File A1-1056

## APPROVAL APPLICATION

Project: Hobbs Creek Restoration, Phase I Remedial Works  
Client: University of Victoria  
Project Code: E2102-001

FIGURE 2: KEY PLAN OF REMEDIAL WORKS FOR CHANNEL HEADCUT

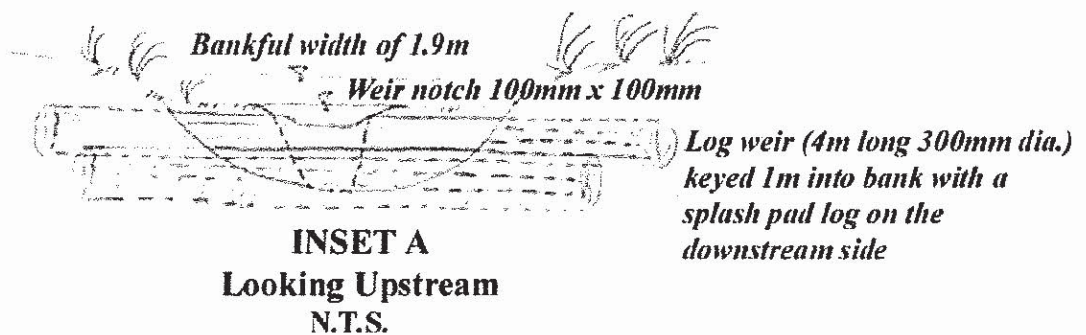
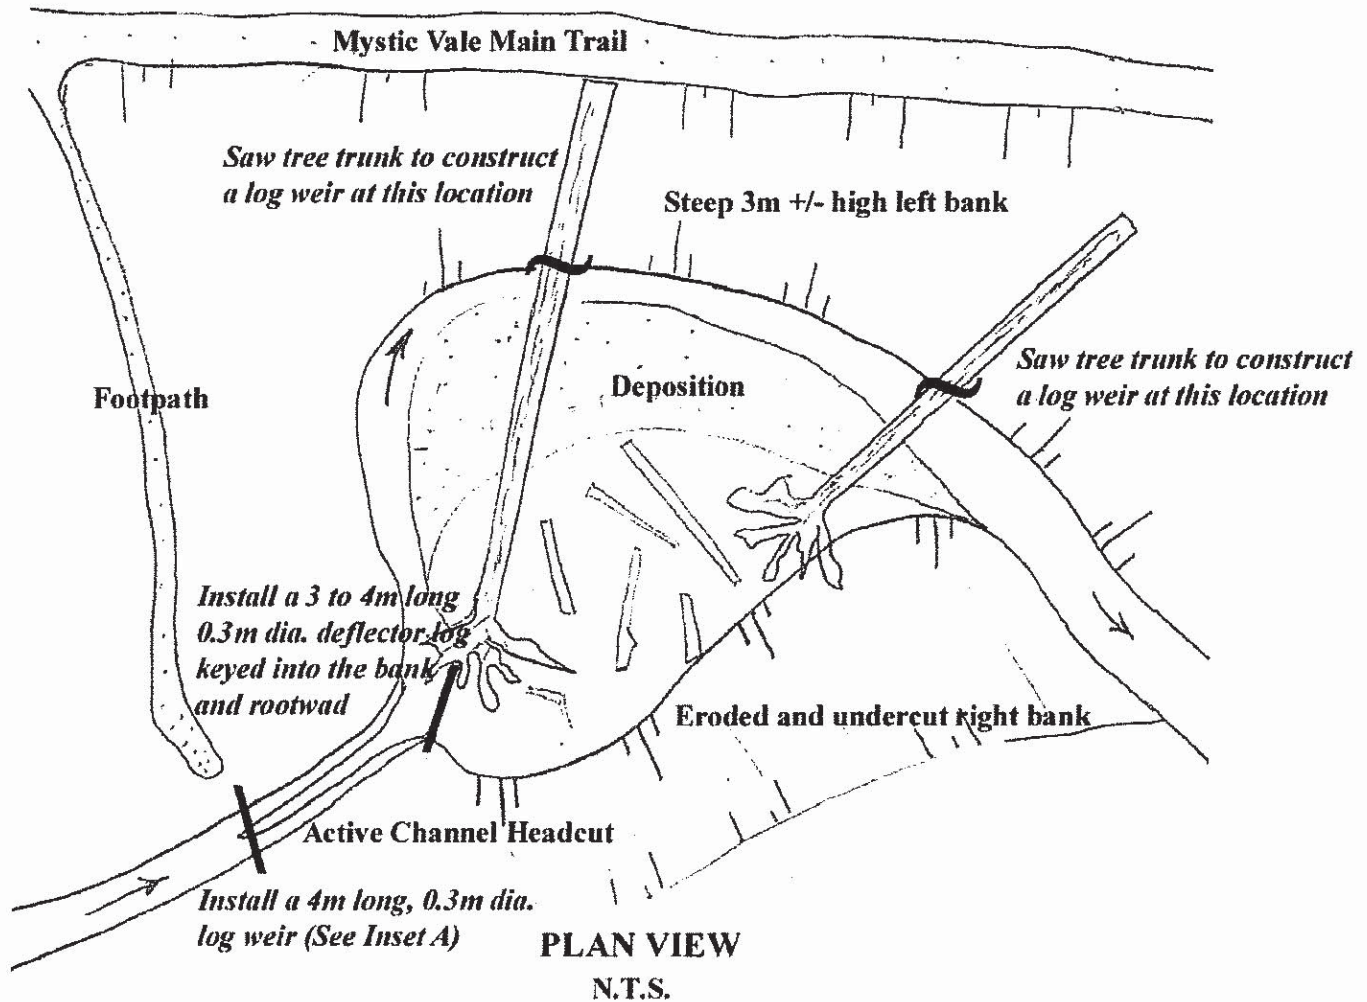
3. All works are to be constructed in accordance with Figure 2, Project E2102-001, by LaCas Consultants Inc., Consulting Engineers and Hydrologists, dated February 6, 2001.

15. The stream bank erosion protection works and remedial works for channel headcut shall be constructed as per conceptual design of channel restoration within a 16m long reach of Hobbs Creek, as submitted with the approval application and signed by the design engineer on February 6, 2001.
16. All works authorized under this approval shall be constructed under the direct supervision of the design engineer and a suitably qualified aquatic biologist.

G:\DRAFT\DES-DWGS\IDsgn2000\115-2000.dwg, 06/26/01 03:11:57 PM, HP DesignJet 1050C NET

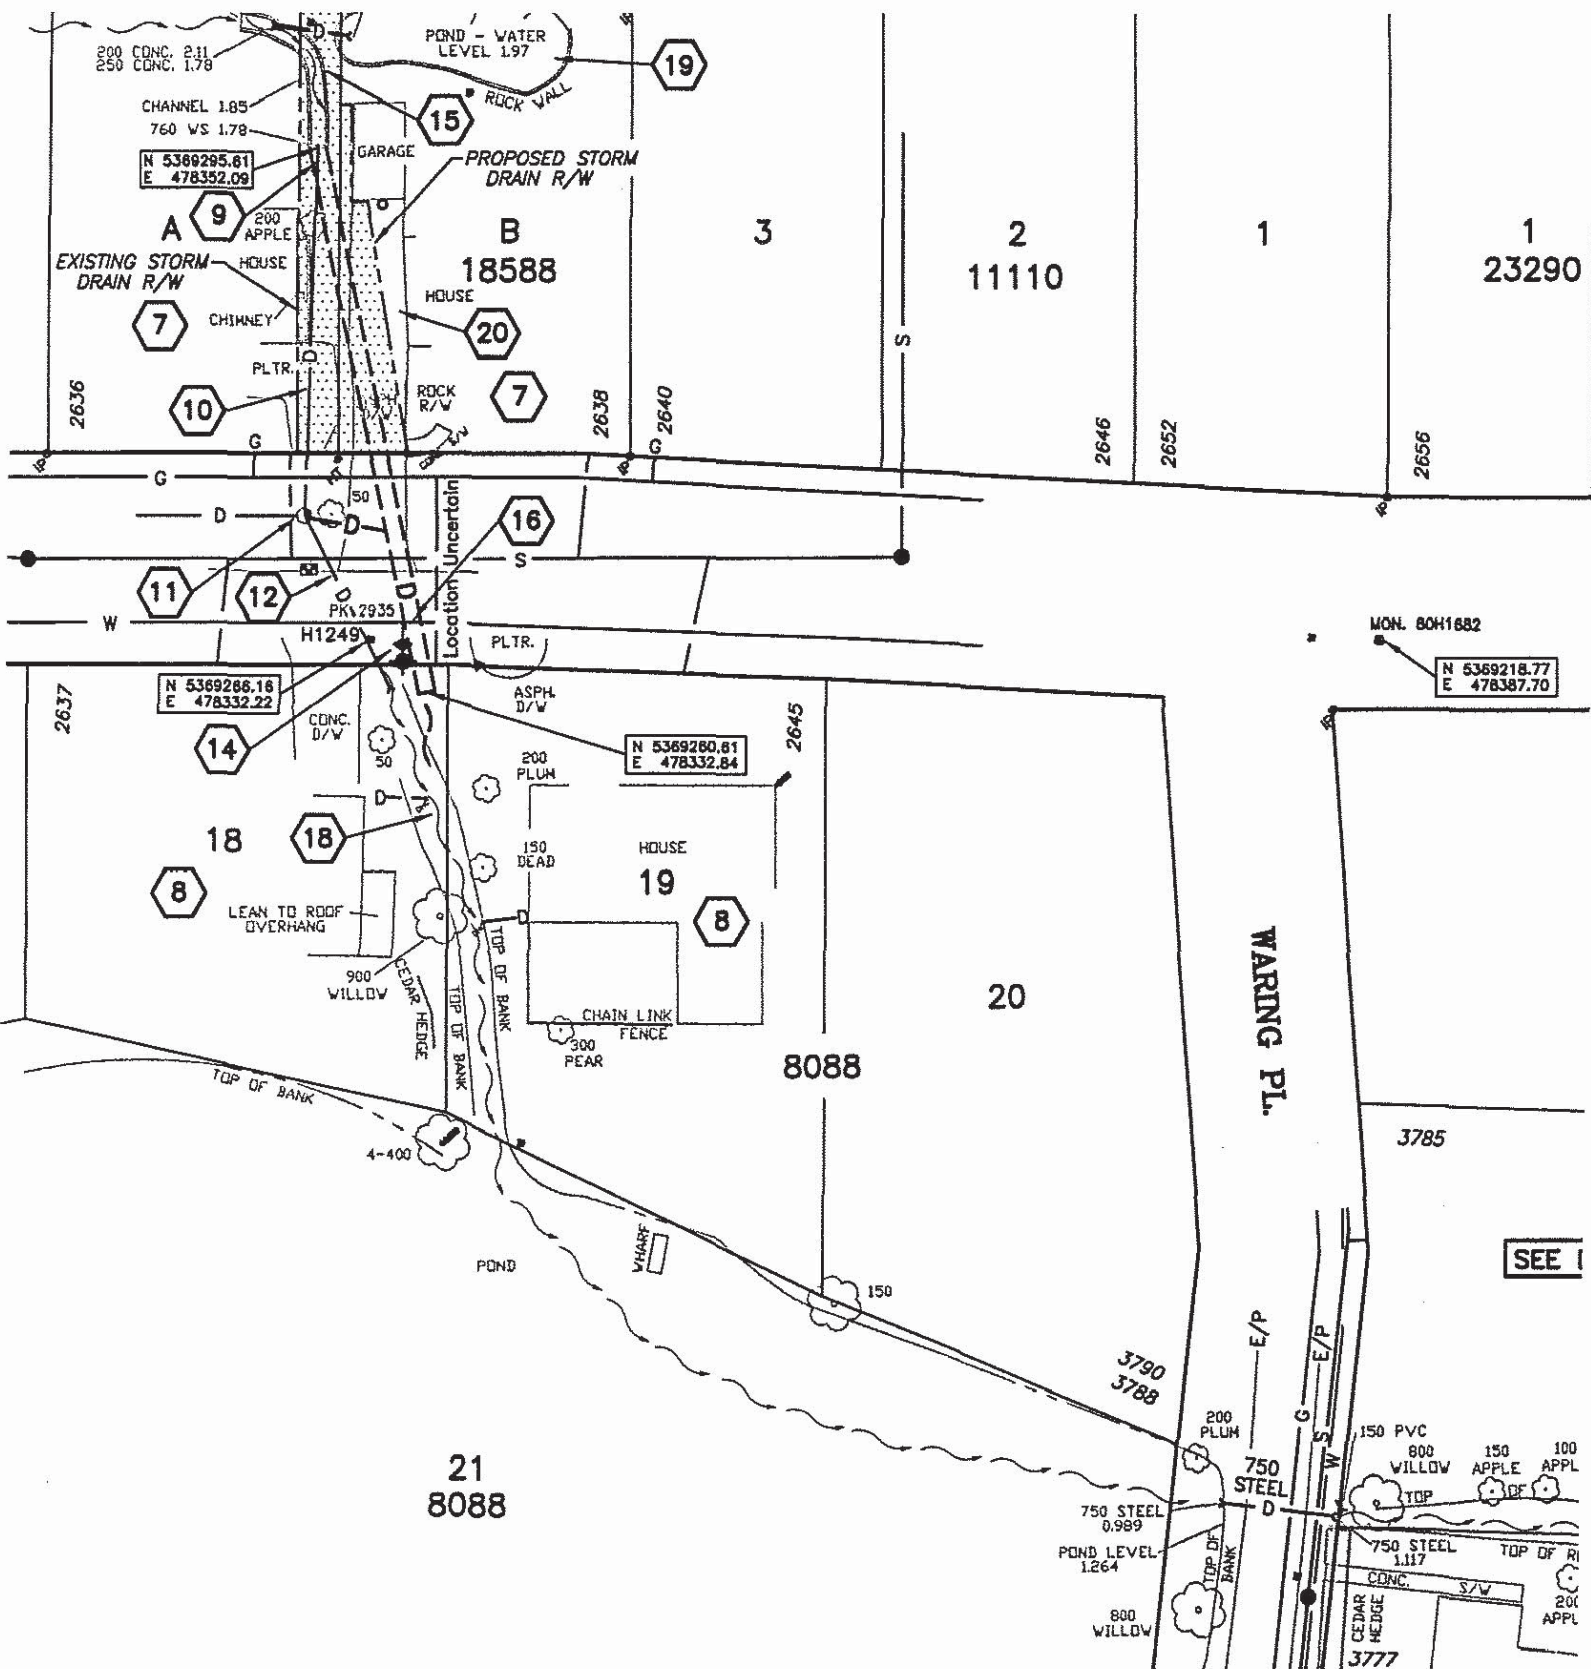
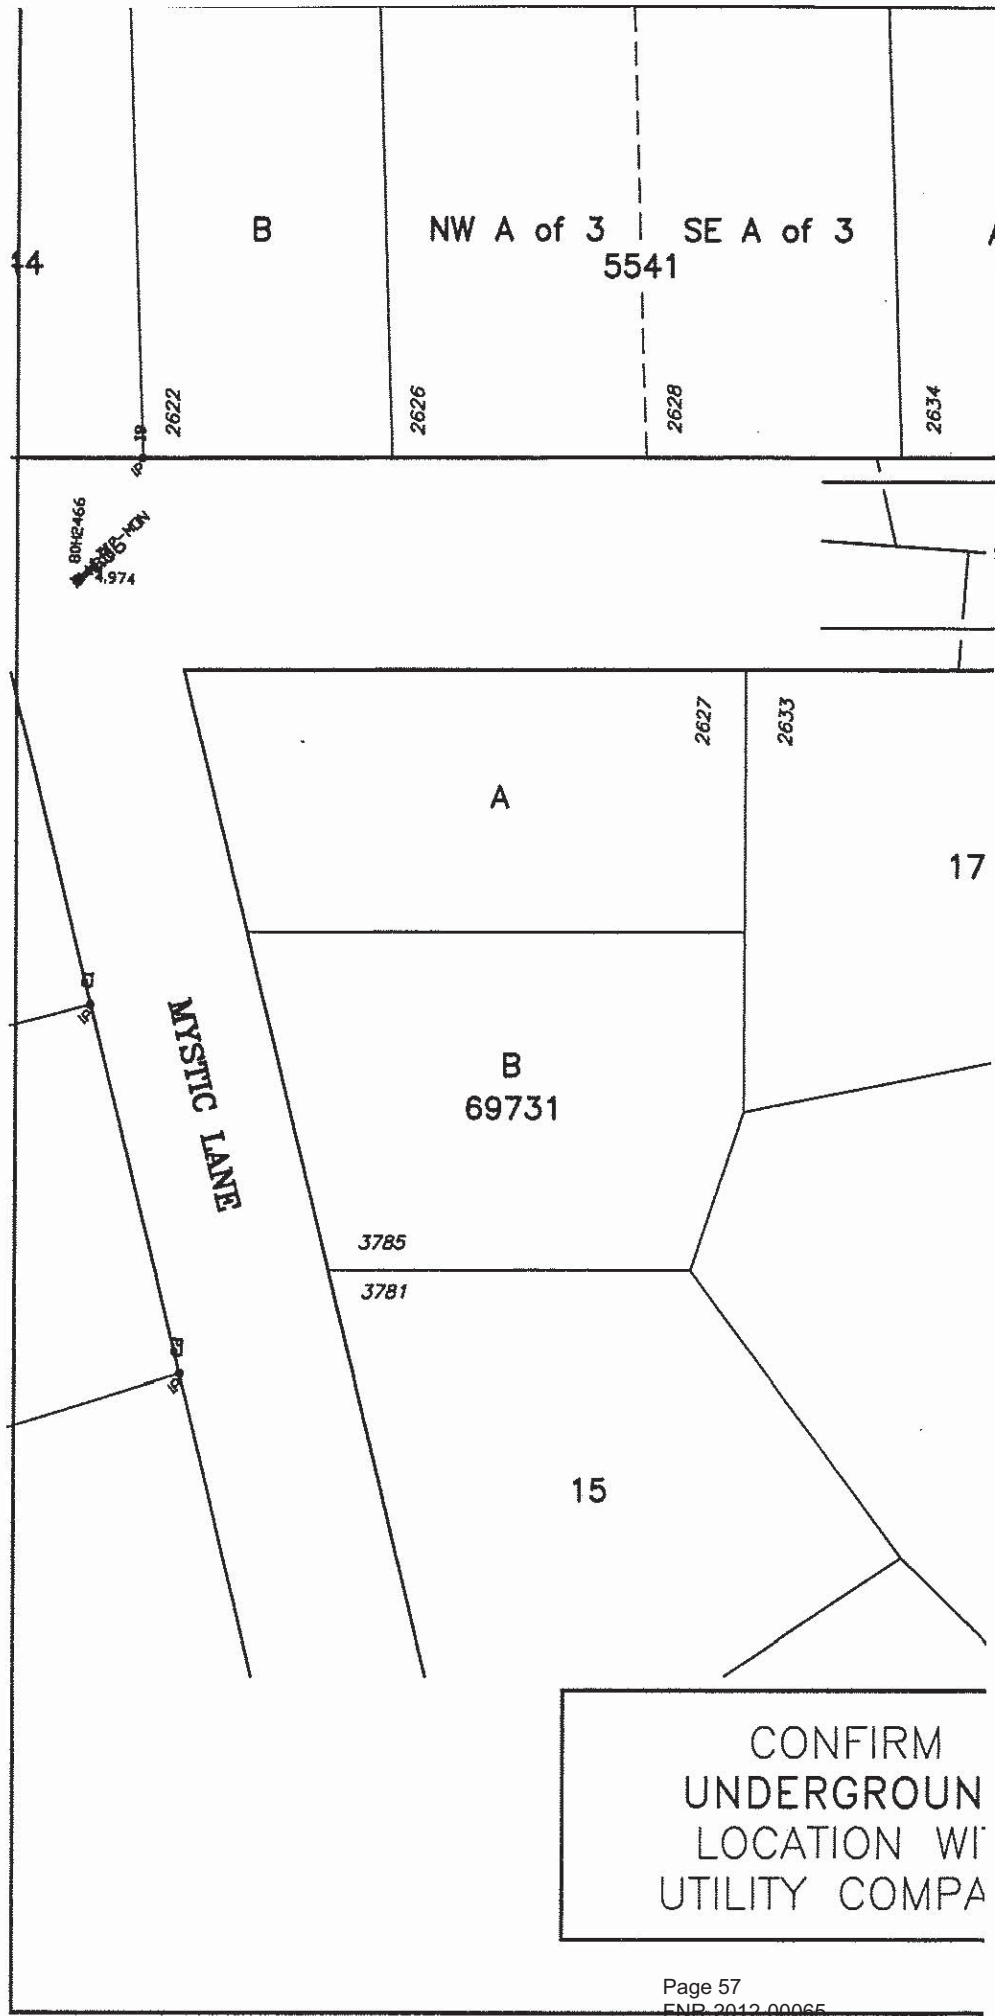
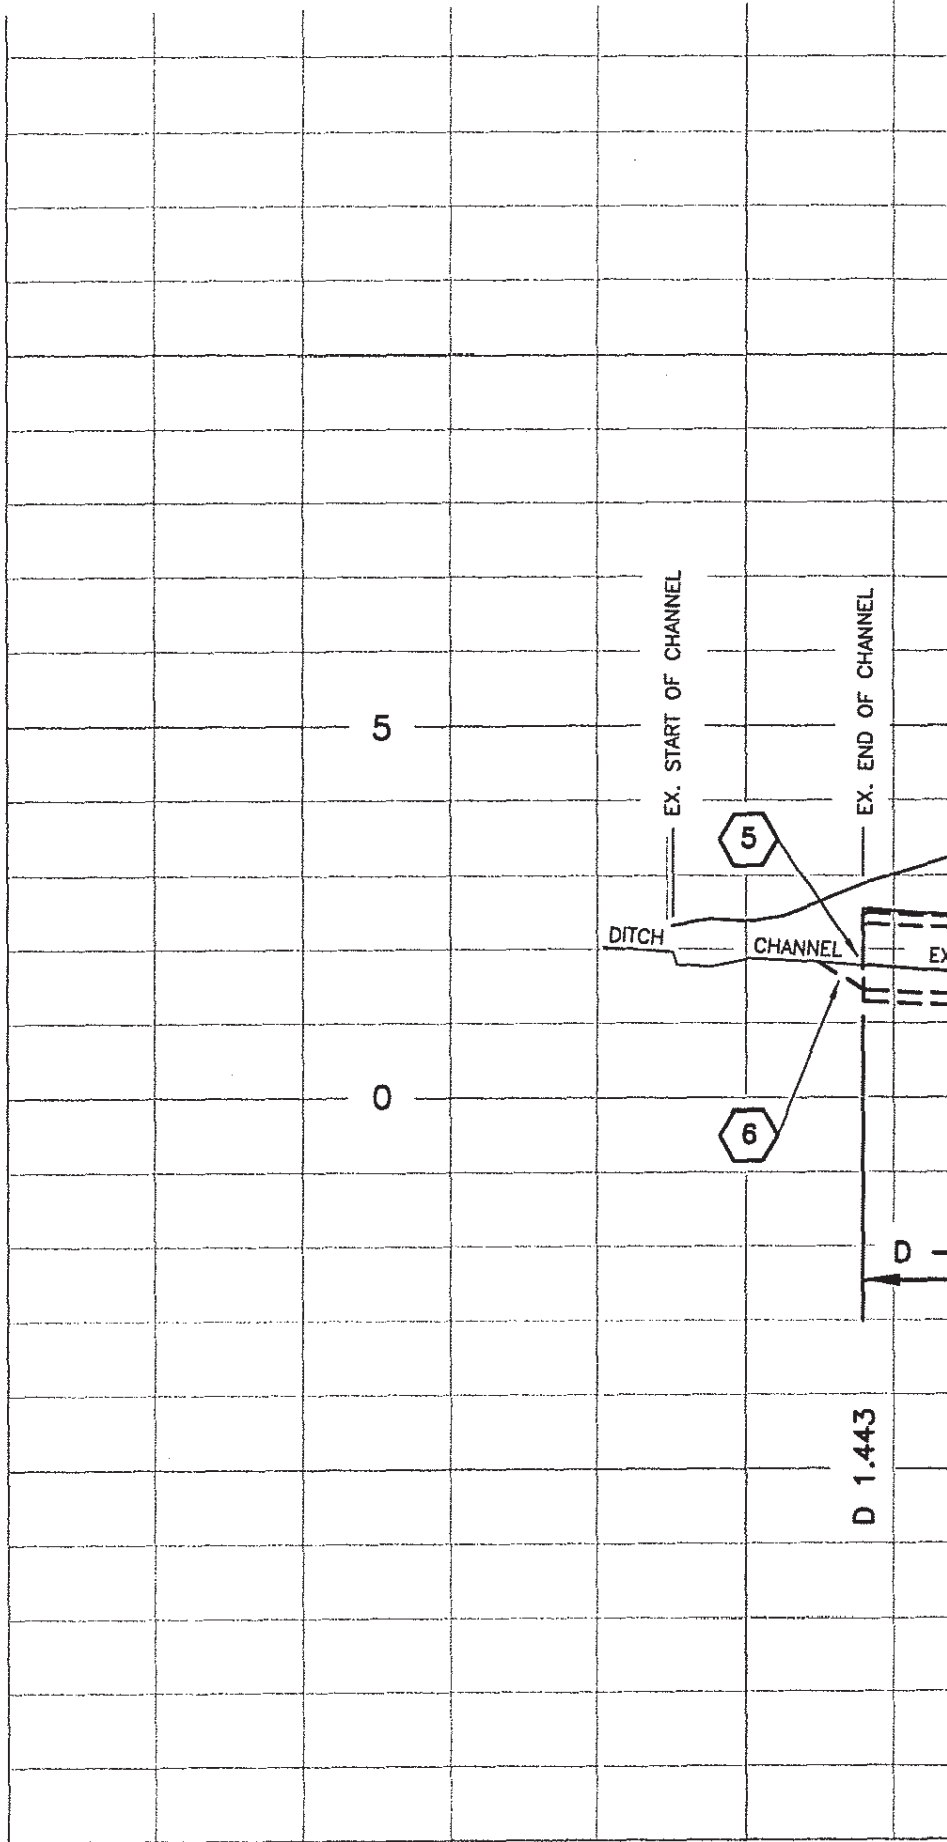
I am responding to your letter of February 14, 2001, to Sharon Erickson and attached drawing No. 115-2000 showing the proposed storm drain pipe replacement beneath Killarney Road on Hobbs Creek.

- We recommend that the pipe be shortened to provide easier fish access.
- We have reservations regarding dredging of the pond. Herons are nesting on the pond which has high habitat values at this time. An environmental assessment should be completed.
- The Department of Fisheries and Oceans' (DFO) review may determine that a Harmful Alteration, Disruption or Destruction (HADD), may result from this work. I note you have also copied your proposal to Cindy Harlow, of DFO who can advise you further on this matter.
- The District of Saanich's Environmental Management team should provide input to your proposal.
- The creek splits just upstream with excess storm runoff being diverted to another outfall in the park (see arrows at 2625 Sinclair). Therefore, the box culvert would need to be set "off level" to allow low flow within the channel.

1. The pipe can be shortened and replaced with vertical mortared rock wall with a gravel lined bottom.
2. Dredging of the pond is necessary to remove the silt build up and will be strictly confined to an area approximately 400mm deep x 1200mm wide over a distance of about 24metres in order to improve flow characteristics of the channel.
3. Angela Evans our Environmental Planner will be investigating the "Heron" concern and will comment on the project as a whole.
4. The creek '*split*' is actually a low flow feed into a small private pond for aesthetic purposes only. It is not for excess run-off.

Your original request for this pipe replacement was dealt with under Approval File No. A1-1058. The drawing you submitted on June 25 shows a slight change in design, which is environmentally better than the original, but is not enough of a change to affect the approval granted on May 1, 2001.
